Determination 2008/32

Dispute regarding the venting of a branch drain using an air admittance valve to a building at 122 Remuera Road, Auckland

Figure 1: Schematic layout of the branch drain

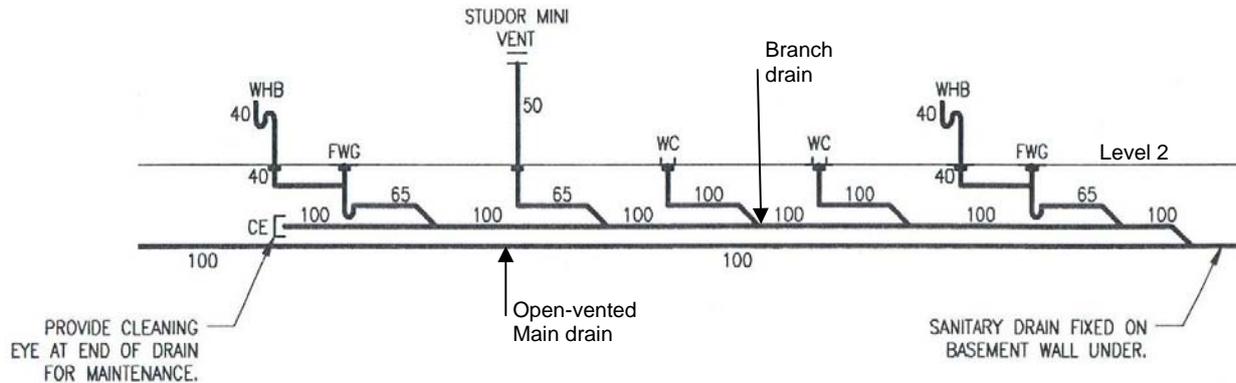
- 2.1 The proposed building is a medical centre containing 3 levels of office accommodation and 1 level of carparking at basement level.
- 2.2 In a letter to the applicant dated 8 February 2008 the territorial authority said:
- [Drawing] shows a branch drain with an air admittance [valve] installed. As this drain is greater than 10 metres in length it needs to have an open vent installed.
- The territorial authority advised the application was “on hold” pending the resolution of the matter.
- 2.3 The branch drain is shown in figure 1. It is located on level 2 of the building and is approximately 13 metres in length. It is vented by an air admittance valve (“AAV”).

The branch drain serves two WC pans, and two wash hand basins which each discharge through a separate floor waste gully. The branch drain is unable to be connected to an adjacent open vent because of a conflict with the building's structure.

[The] plumbing design uses an Air Admittance Valve to protect the water seals on fixture traps that are located on an over-distance branch drain.

Australian Standard 3500.2 20032, Clause 6.9.1, permits the use of [air admittance valves] to ventilate branch drains.

- 4.2 In an email to the Department the territorial authority said it accepted the draft because the length of the branch drain only exceeded the 10 metre maximum drain length in Table 5 of G13/AS1 by about 3 metres. However, the territorial authority submitted that only an open vent could provide surety of compliance with Clause G13.3.2 (e) and preserve water seals to appliances. The territorial authority believed the reliance on AAV's exposed building users to unnecessary risk.

- 4.3 In response I note the principal function of AAV's is protect the water seals of fixture traps to avoid foul air and gases entering buildings. In this instance the requirements of G1.3.2 (e) will also be met because the number of fixtures on the branch drain will ensure air is drawn into the drain when the fixtures are discharged. There are therefore situations when there would be insufficient fixtures to ensure air is drawn in through an AAV and an open vent would be required.

5.15 In summary, venting branch drains with suitably-sized AAV's is an acceptable alternative to the use of an open vent.

6.1 In accordance with section 188 of the Building Act 2004, I confirm that the use of an AAV on the branch drain as described herein complies with the Building Code and according reverse the territorial authority's to decline to issue the building consent.
